From: Curley, Jane
Sent: 02 May 2023 15:10
To: Planning Comments (SMDC)
Subject: FW: Further objections arising from the Quarry 3 instability and dangers / the lagoon and safety regulations in respect of SMD/2019/0646 and SMD/2022/0014

Subject: Further objections arising from the Quarry 3 instability and dangers / the lagoon and safety regulations in respect of SMD/2019/0646 and SMD/2022/0014

Long Section Fig

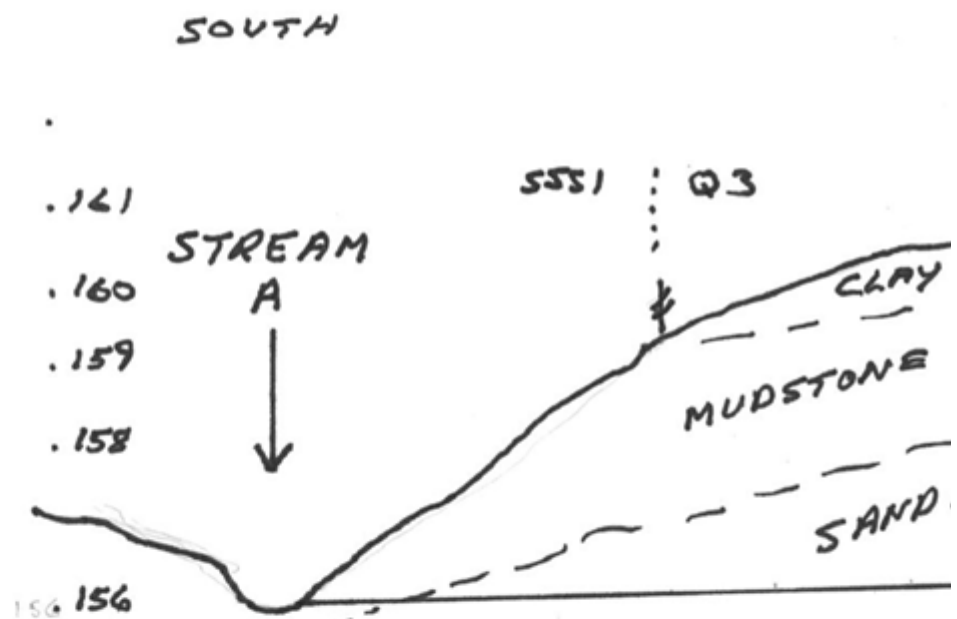
This quality of drawing or illustration is just not acceptable.

There is no sign of a proper standard of presentation that should be required for planning purposes; no legend or key, no proper scale etc.

It has the air of a rudimentary sketch and more to the point, the profile in this section drawing which purports to be of the same area, looks outwardly different to the reality on the ground.
